US 24 West Environmental Assessment Finding of No Significant Impact and Section 4(f) Evaluation

CDOT Project Number: 07 HA2 00011
CDOT Project Control Number: NH 0242-040

US Highway 24 West Finding of No Significant Impact
and Section 4(f) Evaluation
El Paso County, Colorado

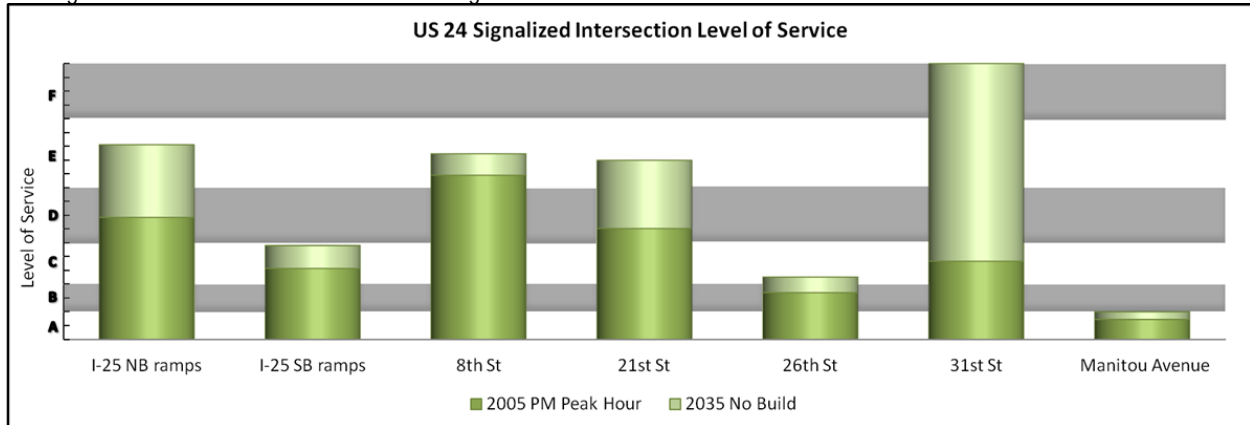
Section 1.0 of the EA stated on **page 1-2** that “US 24 is used for an express bus service for commuters between downtown Colorado Springs and Manitou Springs, with service further west to mountain communities”. This statement was correct when the EA was written, but was out of date by the time the EA was approved in May 2012. Ute Pass Express bus service was discontinued on October 28, 2011 due to low ridership. A citizen pointed this out in his submittal during the EA public comment period.

Delete from the EA on page 1-2, third paragraph following the bulleted items:

ADDITION TO EXHIBIT 2-8
Proposed Lane Configuration at US 24 Intersections

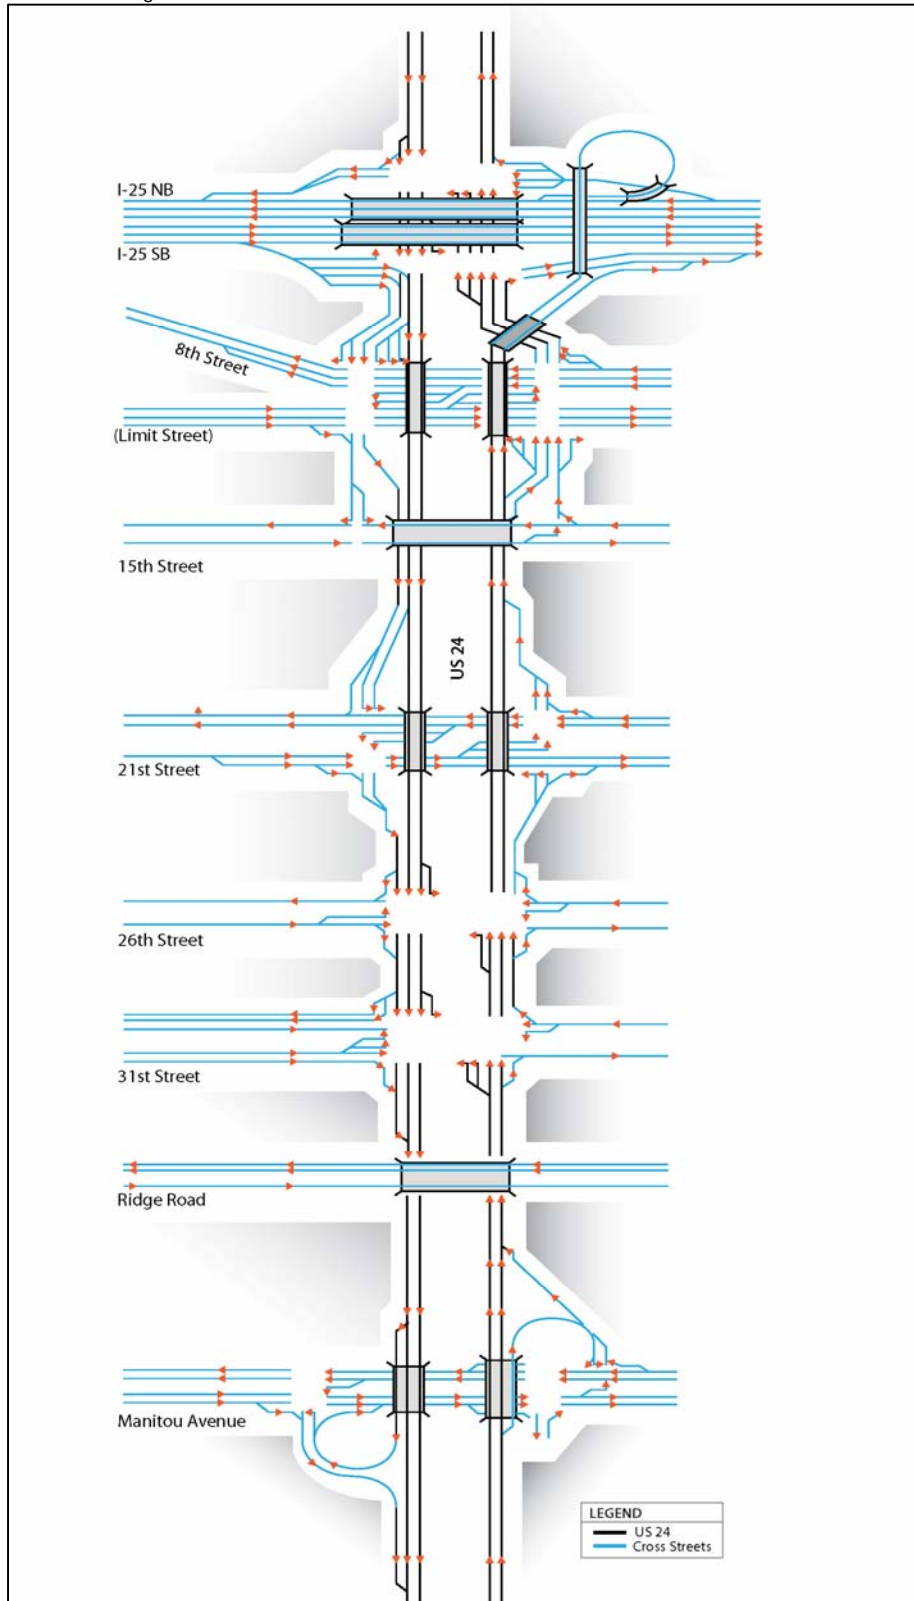
Section 2.4, Description of the Proposed Action, in the US 24 West EA included two exhibits providing a graphic illustration of the project. In addition, details of the lane configurations proposed for each intersection along US 24 were included in **Appendix C, Technical Memoranda**, of the US 24 West EA in the *Traffic Impact Analysis Technical Memorandum*. A drawing showing the detailed lane configurations for each of the cross-streets along US 24 is included in *Traffic Impact Analysis Technical Memorandum* to help the reader understand the lanes at each intersection. A more user-friendly version of that graphic is being added to Section 2.4 of the EA due to the number of citizen questions asked on this topic at the public hearing open house.

Add to the EA on page 2-14, immediately following **Exhibit 2-8:**

Exhibit 2-8 also shows the lane configuration at each intersection / interchange and along the segments.

EXHIBIT 2-9
Potential Construction Packages and Options not Precluded by the Proposed Action

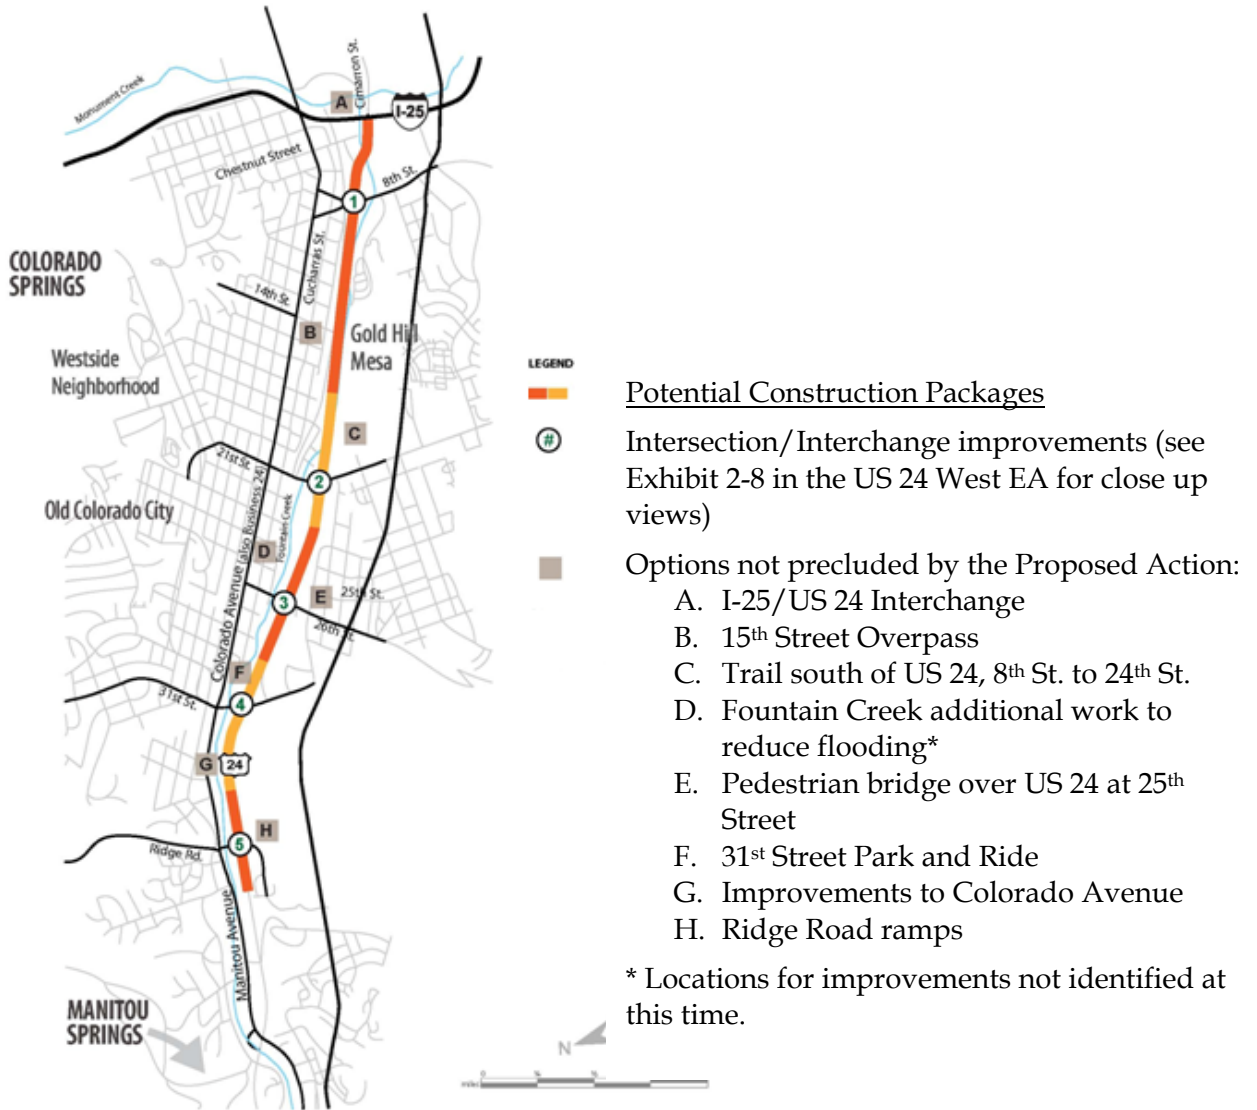
Add to the EA, after the last bulleted item (note: originally **Exhibit 2-9** is replaced):

Exhibit 2-9 illustrates all of the options listed in the US 24 West EA that could be built as separated projects, by CDOT or others.

Comment Number: 52

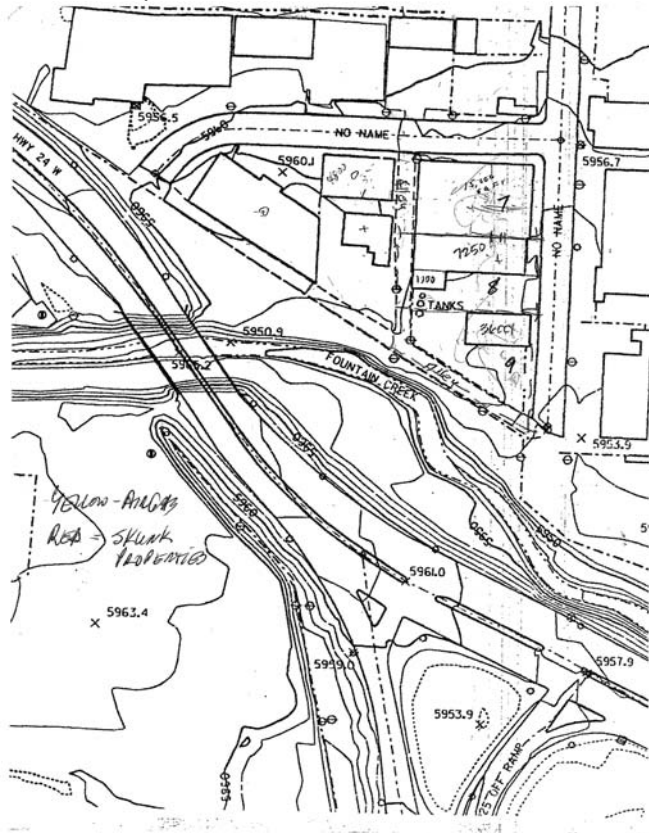
Jack Damman, owner of the property at 306 S. Chestnut, had a verbal conversation with Dave Watt, Resident Engineer with CDOT. Mr. Damman said that there are additional affected properties beyond the one parcel the environmental assessment shows impacted (parcel 9 at 306 S Chestnut). The additional properties are currently occupied by Air Gas and are tied to the common business operations. The properties are parcel 7 and 8 on the attached map.
